Technical Bulletin

Number 119
November 1982

Spool Assembly Service Kit 673089

Models: 20D, 35D and 60D Carton Clamps

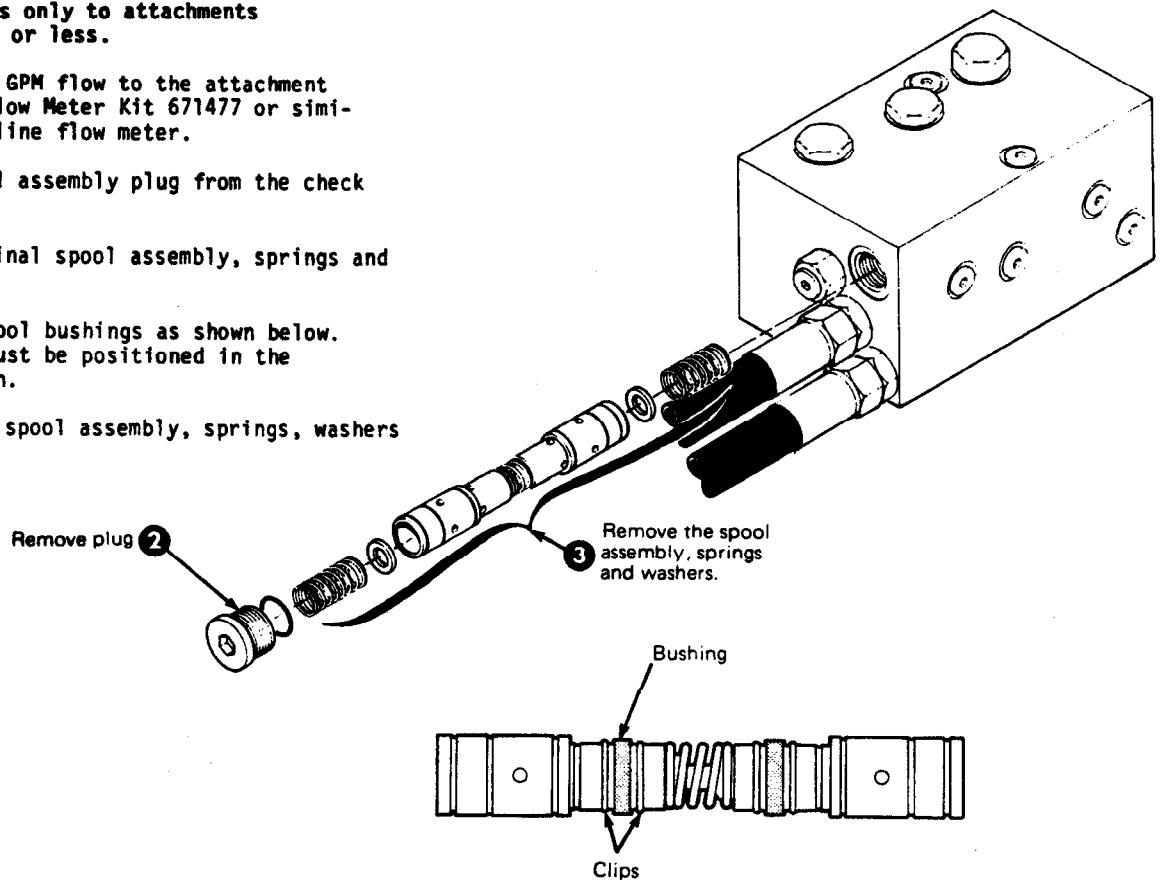
Problem: Carton Clamps mounted on trucks supplying less than 8 GPM hydraulic flow are experiencing unequal arm movement due to the low flow volume.

Solution: Replace the existing valve spool assembly with Spool Assembly Service Kit 673089.

- 1 Check the truck GPM flow to the attachment using Cascade Flow Meter Kit 671477 or similar 1-20 GPM inline flow meter.
- 2 Remove the spool assembly plug from the check valve body.
- 3 Remove the original spool assembly, springs and washers.
- 4 Position the spool bushings as shown below. Both bushings must be positioned in the inboard position.
- 5 Install the new spool assembly, springs, washers and plug.

1 THROUGH 8 GPM FLOW - Position bushings and clips inboard.
